# **A New Method to Accurately Estimate ( $ADD, \sigma_{RJ}$ ) of Dual Dirac Jitter Model from ( $J3u, JRMS$ )**

(A presentation related to draft 2.0 comments #134, 135)

Mike Li, Masashi Shimanouchi, Hsinho Wu  
Intel

May 2021

# Problem Statement (1/2)

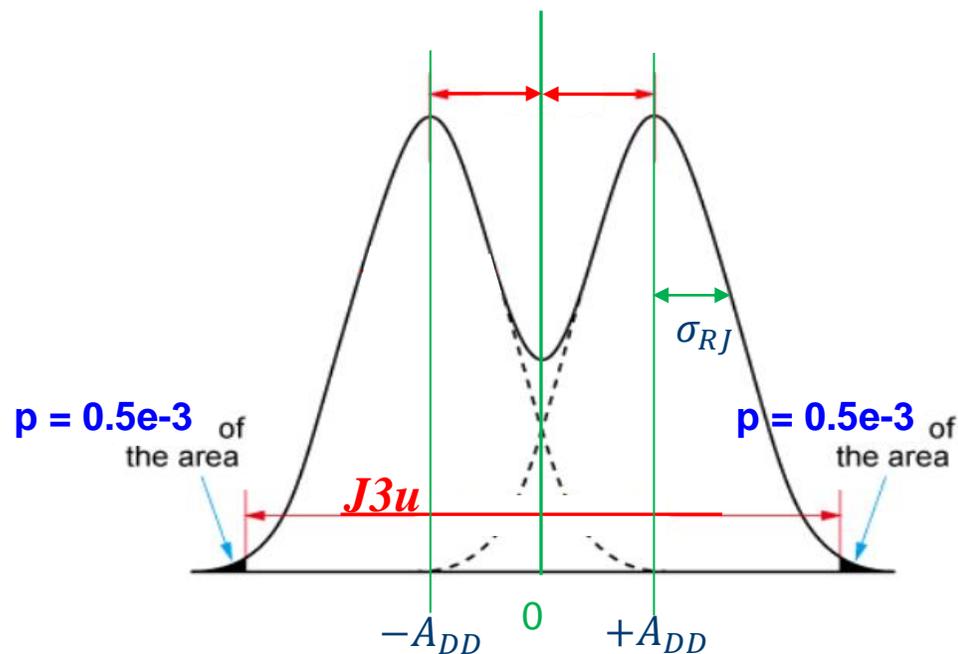
- The method to estimate  $(A_{DD}, \sigma_{RJ})$  from  $(J_{3u}, J_{RMS})$  specified by (802.3: 163-2&3) can be derived from Dual-Dirac model (DD-Model Eq.1&2).
- However, solving the set of equations (DD-Model Eq.1&2) for  $(A_{DD}, \sigma_{RJ})$  for a given  $(J_{3u}, J_{RMS})$  is not mathematically straightforward because of the 3<sup>rd</sup> unknown  $Q3$ .
- **Three unknowns/variables with two equations, an under-determined non-linear system !!!**

# Accuracy Evaluation of Estimated $(A_{DD}, \sigma_{RJ})$ (3/3)

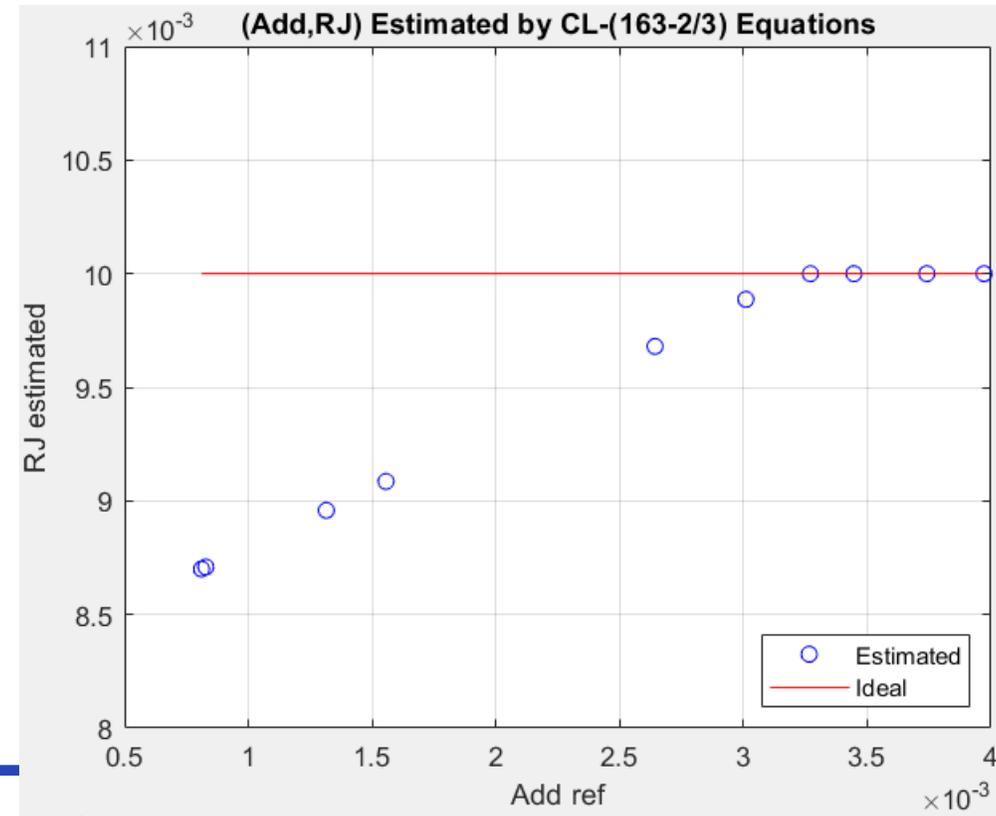
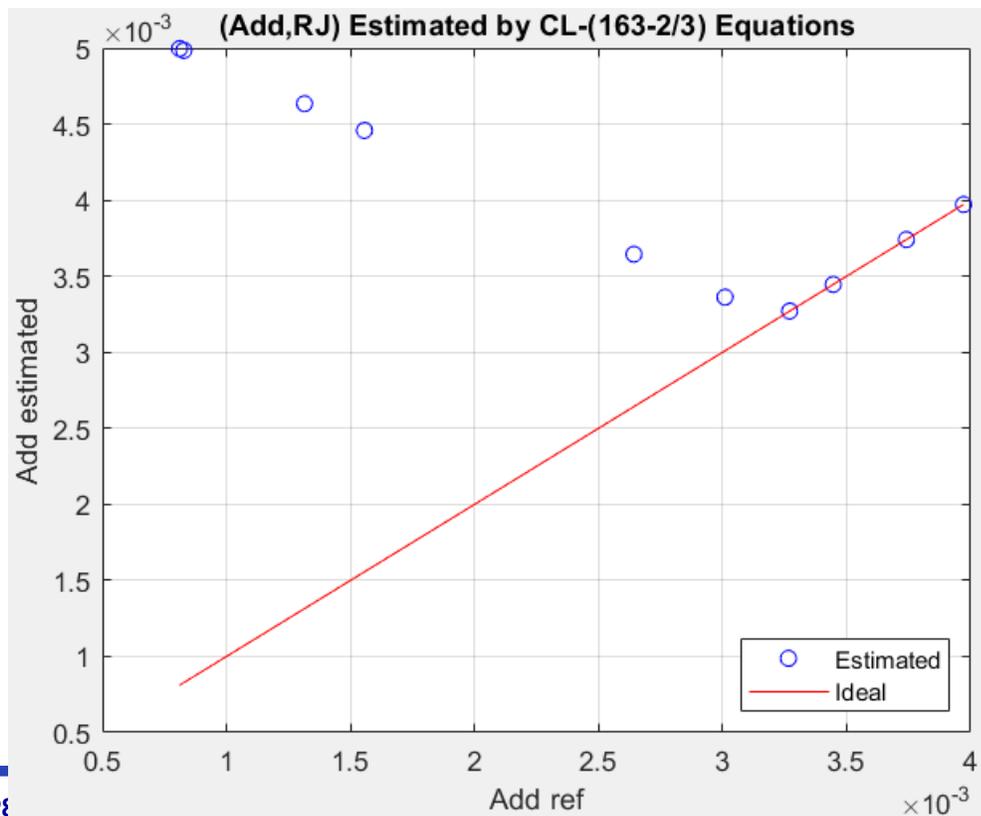
- Why equations (802.3: 163-2&3) are not used to estimate  $(A_{DD}, \sigma_{RJ})$  once Q3 is accurately estimated by the new method
  - As shown below, equations (802.3: 163-2&3) do not very accurately estimate  $(A_{DD}, \sigma_{RJ})$  even with very accurately estimated Q3 value when  $A_{DD}$  is very small
  - Many uses of Q3 in these equations, especially in (802.3: 163-2), seems to amplify very small error in Q3 resulting in “relatively” large error in  $(A_{DD}, \sigma_{RJ})$

# Inaccuracy due to Limited LUT Range

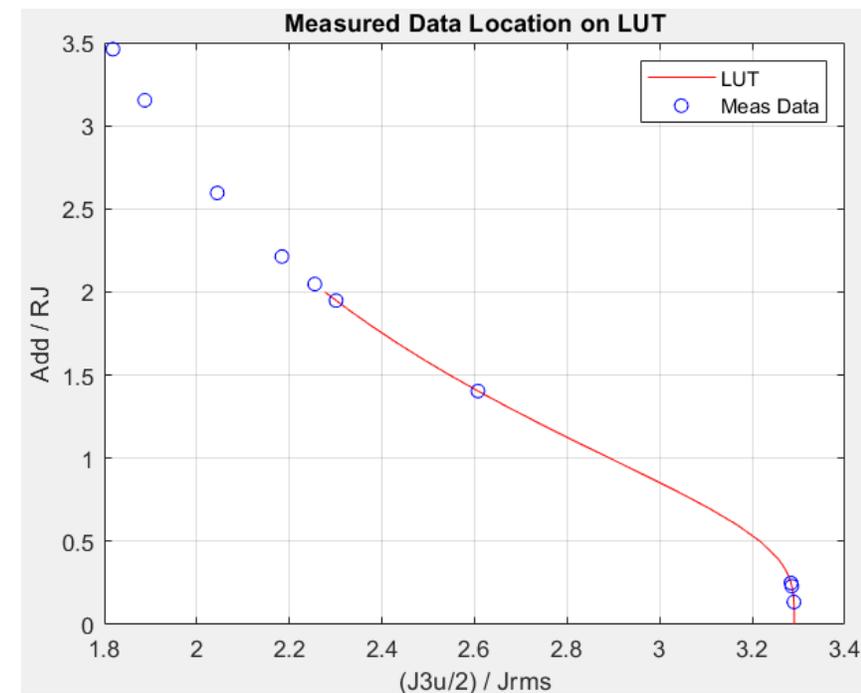
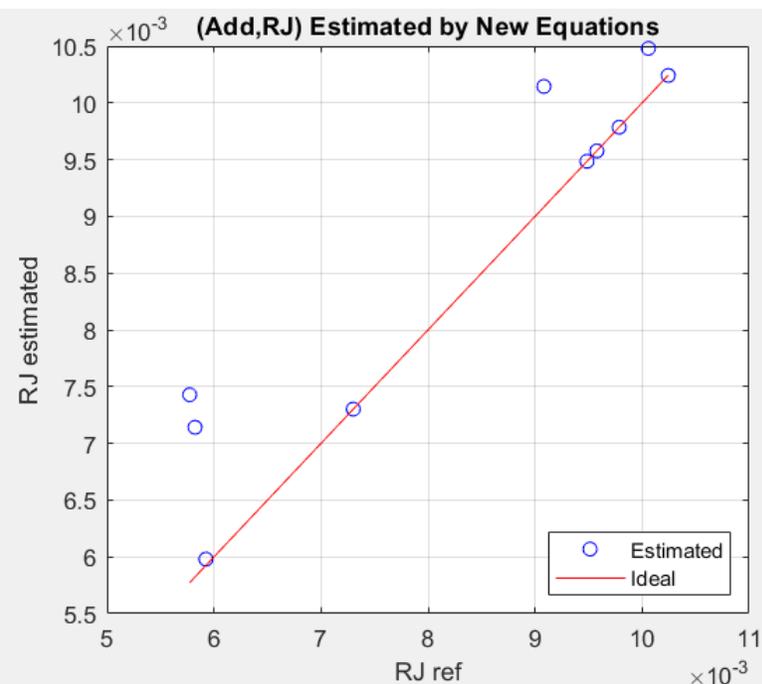
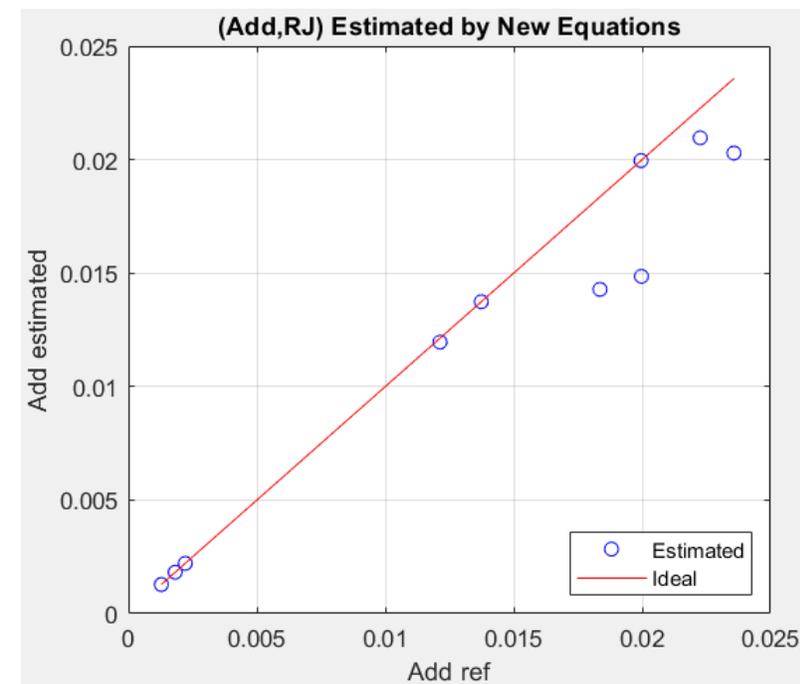
- Test data set ( $J_{3u}, J_{RMS}$ ) generated from ( $A_{DD}, \sigma_{RJ}$ )
  - $A_{DD} \sim \text{unifrnd}(0, 0.025)$ ,  $\sigma_{RJ} \sim \text{unifrnd}(0.005, 0.012)$
- LUT  $A_{DD}/\sigma_{RJ}$  range: 0 ~ 2.0

$(A_{DD}, \sigma_{RJ})$  estimation accuracy degrades when LUT does not cover

# High Accuracy Maintained by Wider-Range LUT

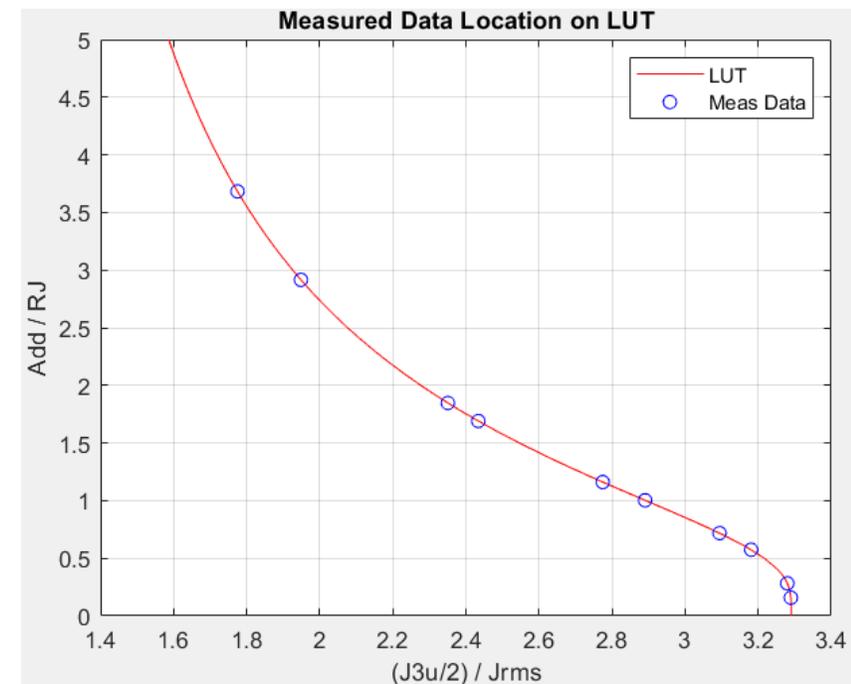
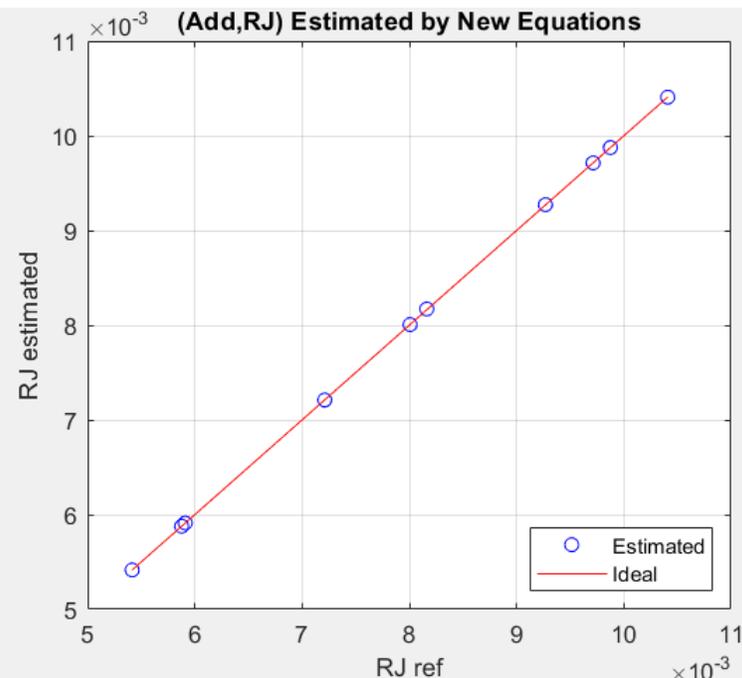
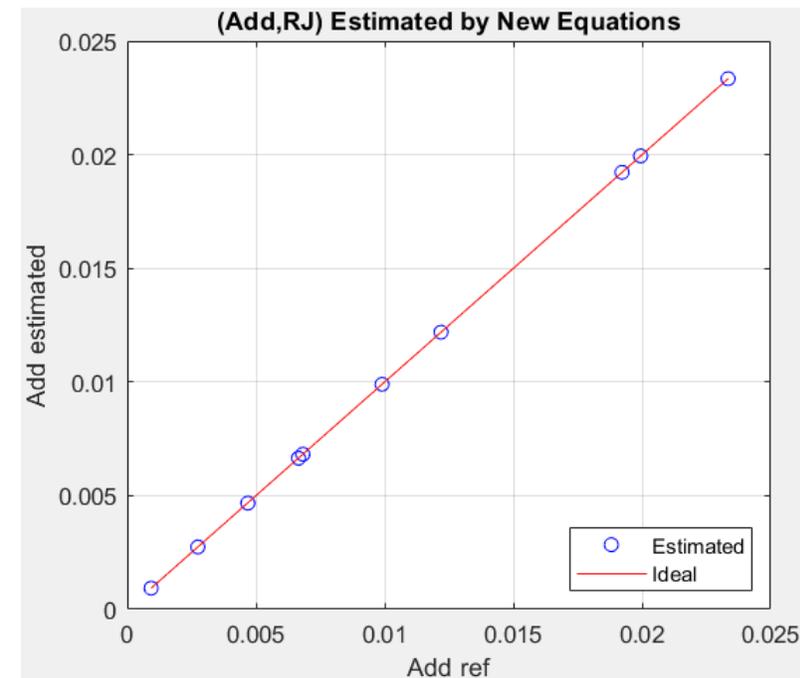
- Should not rely on “extrapolation” of LUT

Good ( $A_{DD}$ ,  $\sigma_{RJ}$ ) estimation accuracy for large data range

LUT extended to cover large  $A_{DD}/\sigma_{RJ}$
